Responses to the ICN FAQs

ICN released a list of FAQs on their website and we believe some responses require further explanation or are factually inaccurate. In the document below, each FAQ is listed with the “ICN response”, followed by a “RESIDENT response”. Each “RESIDENT response” provides factual data as researched by the resident committee of the surrounding neighborhoods.

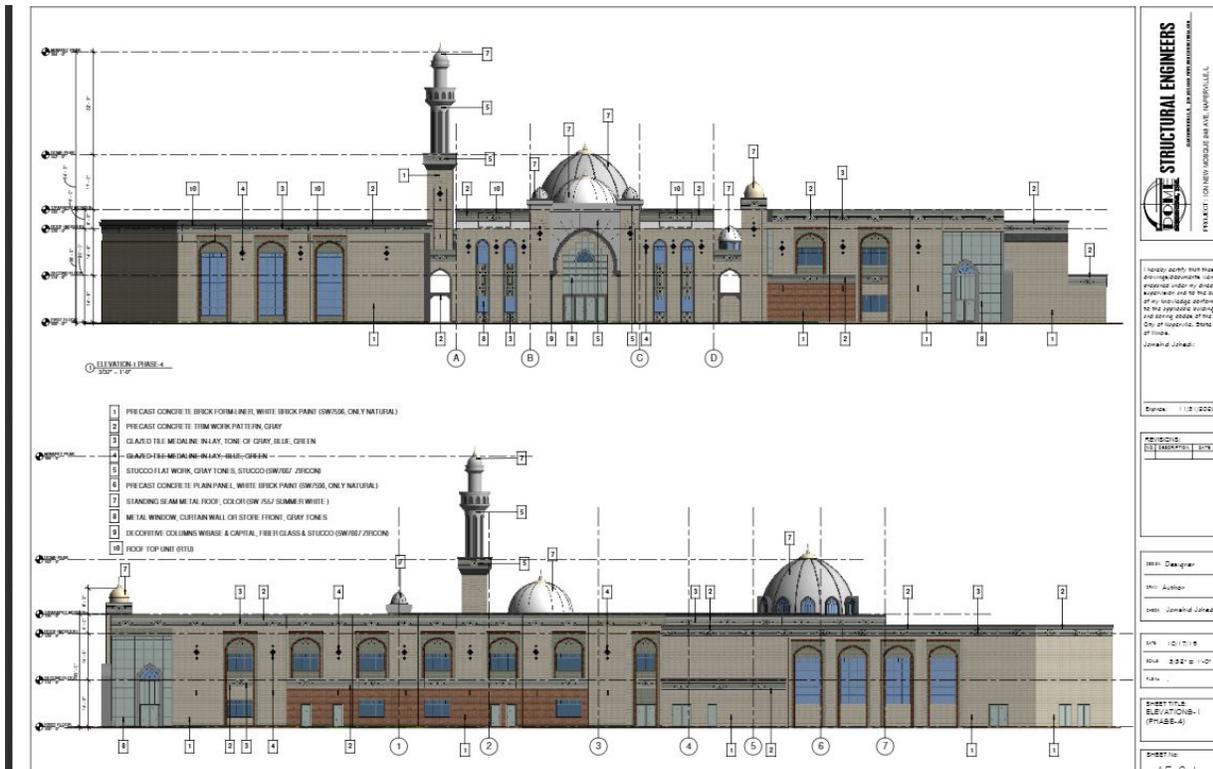
- The total height of the structure would be 84 feet high, as proposed
- The structure consists of multiple components; roof height of 29 feet, parapet height of 35 feet, domes at 52 feet high (nearly 20 feet higher than the adjacent residential homes), and an 84-foot minaret. While we understand that the heights are within code and we are not disputing this, the reality is that nearby homeowners are going to see a structure with 52 feet high domes and an 84 foot minaret, much higher than the surrounding homes, as the view from their backyards.

- The drawings below are a depiction of what the structure would look like at the end of completion.

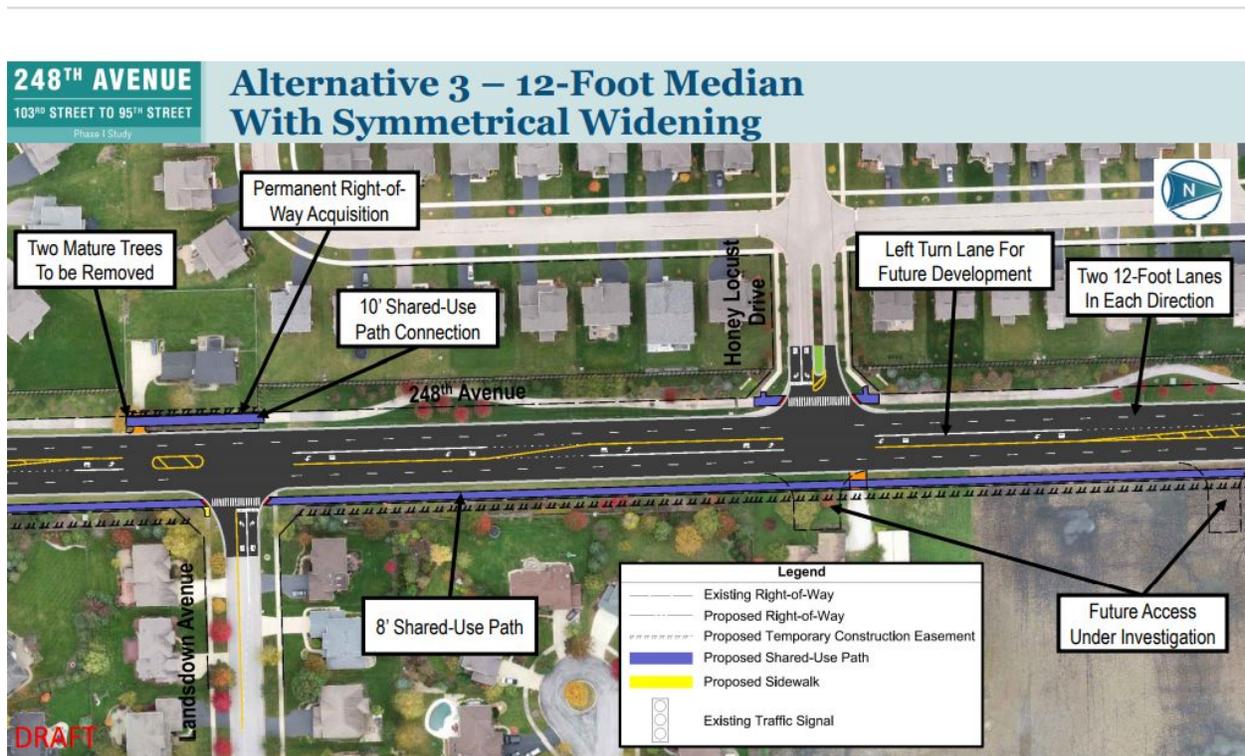
- If allowed, this variance will move the entire site 10 feet closer to the 248th Ave. roadway reducing the amount of open space in the 248th Ave. parkway creating a potential safety issue for the motoring public.
- Compounding the safety issue, once 248th Ave. is widened, the existing roadway will be that much closer to the proposed parking lot.
- This variance would also bring the site in close proximity to the proposed shared use path planned in the 248th Ave. expansion project. As shown in the picture below, the blue line running on the east side of 248th Ave. shows the City's plan to build the 8ft wide shared use path.

- Not building a fence will increase the risk for cut through pedestrian traffic by attendees attempting to avoid the congestion of the ICN parking lot and related traffic on 248th Ave.
 - Parking on Lapp Ln. in Penncross Knoll subdivision and walking between the homes to the ICN premises. There is no way to prevent that from happening and the privacy of residents will be severely impacted due to this. A fence is more likely to discourage this behavior.
 - Parking on Tall Grass Dr. in Tall Grass and walking up the Tall Grass Greenway Trail
- The variance would alter the essential character of a quiet, residential neighborhood by not providing a buffer between two different land use types with different intensities.

(i) Variance to allow parking in the front yard setback. Additional landscaping will be installed to provide a screen between the street and the parking lot. City staff is supportive of this variance since no residential driveways are located on the east or

west side of the street. The variance allows the building to be further away from the neighbor on the east.

(ii) Variance to eliminate the fencing requirement along the north property line - this is to maintain a feeling of openness from the adjacent trail and greenway. The neighbors across the greenway are over 200 feet away. ICN will provide a landscape buffer along this property line. City staff is supportive of this variance since there are no residences directly adjacent at this location.
